#2011-56 Kyoto Restaurant Project Review for Planning and Zoning Commission

<u>Meeting Dates:</u>	November 2, 2011
<u>Requests:</u>	Final PUD Amendment to permit three backlit architectural pieces on the exterior elevations.
<u>Location:</u>	5690 Northwest Highway
<u>Acreage:</u>	1.24 acres
<u>Existing Zoning:</u>	“B-2 PUD” General Commercial Planned Unit Development
<u>Surrounding Properties:</u>	North - “B-2 PUD” General Commercial- Sam's Club South - “B-2 PUD” General Commercial- Colonial Cafe East - “B-2 PUD” General Commercial- Richard Walker's West - “B-2 PUD” General Commercial- Boston Market
<u>Staff Contact:</u>	Michelle Rentzsch 815-356-3615

SOUTH ELEVATION

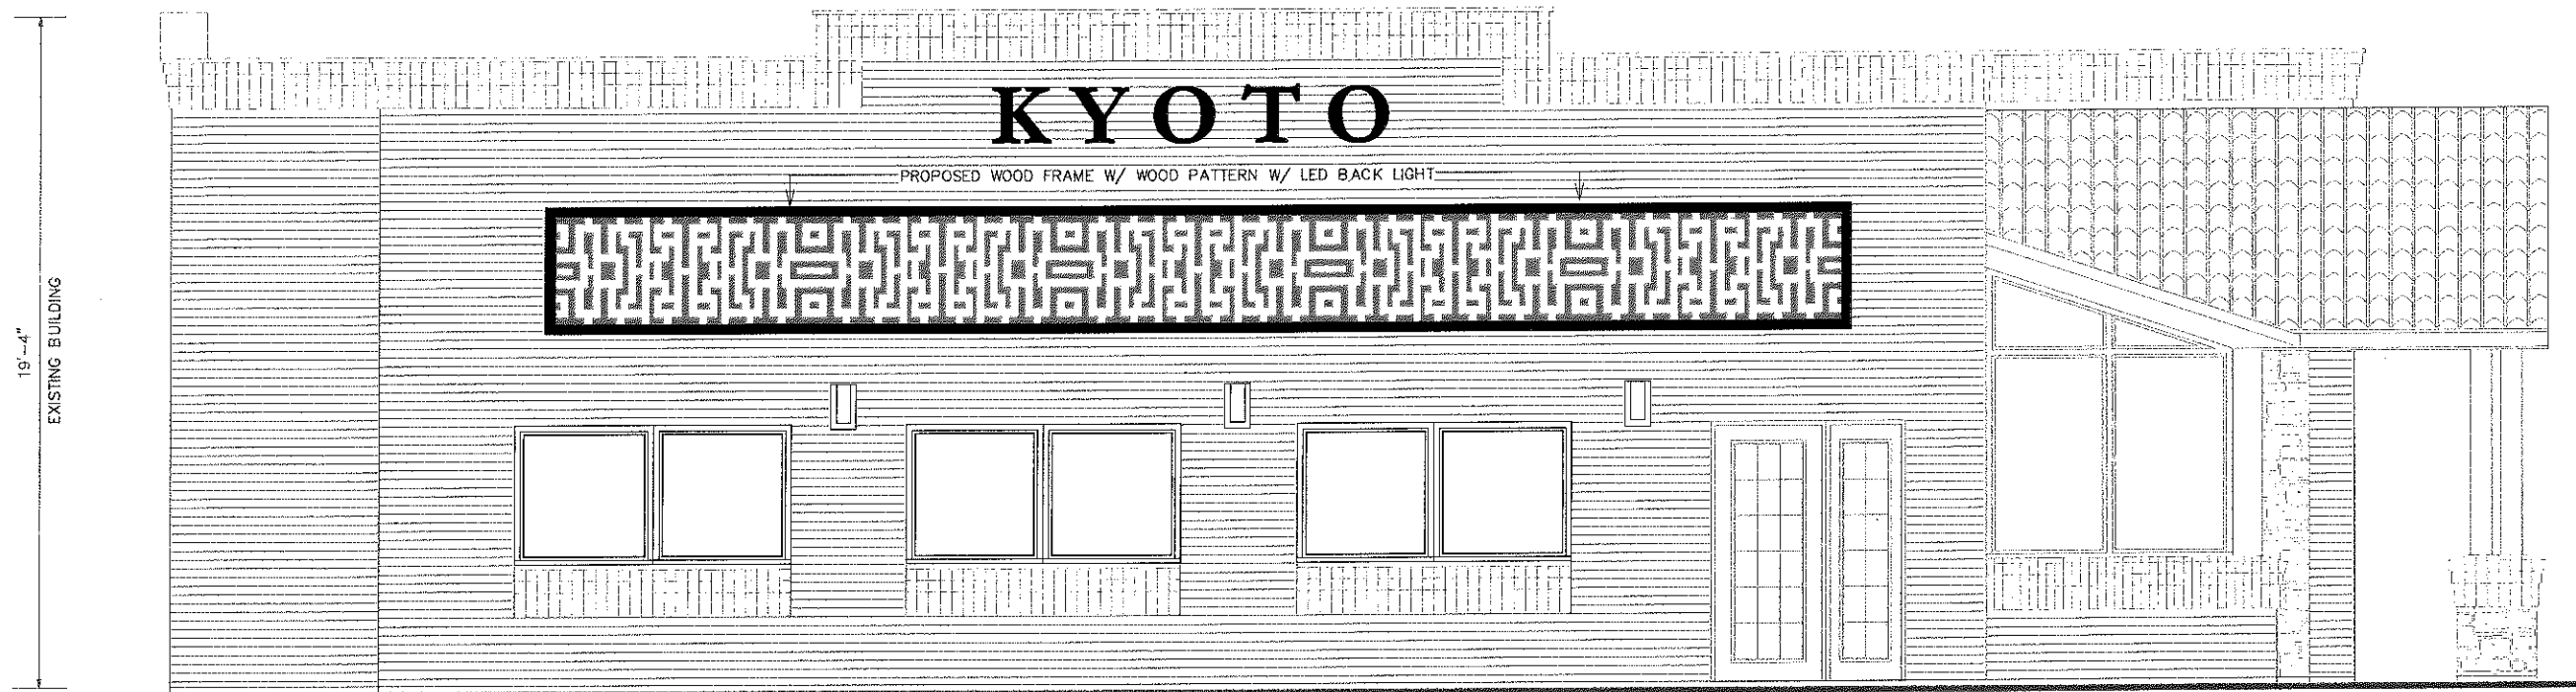
- There would be a total of three lighted pieces: two longer pieces on the south and west elevations and a shorter piece above the door on the southeastern side of the building.

Technically, the proposed backlit architectural pieces appear to need a variation from this requirement.

If these architectural pieces are considered to be signage, then the total "signage" for this building would be 350.5 square feet. Two "Kyoto" signs at 17.25 square feet each (34.5 sf total) plus three backlit architectural pieces (160 sf, 128 sf, and 28 sf = 316 total sf).

1. Approved plans, reflecting staff and advisory board recommendations, as approved by the City Council:
 - A. Application, (Wichman for Kyoto, received 10-21-11)
 - B. Site Plan, (Meyer, received 10-21-11)
2. The LED lighting shall remain a constant blue "water-like" color.
3. As a condition of the Final PUD Amendment, variations are granted to allow the proposed architectural pieces that meet the final requirements of the Planning & Zoning Commission and the City Council.
4. The petitioner shall address all of the review comments and requirements of the City's Departments.
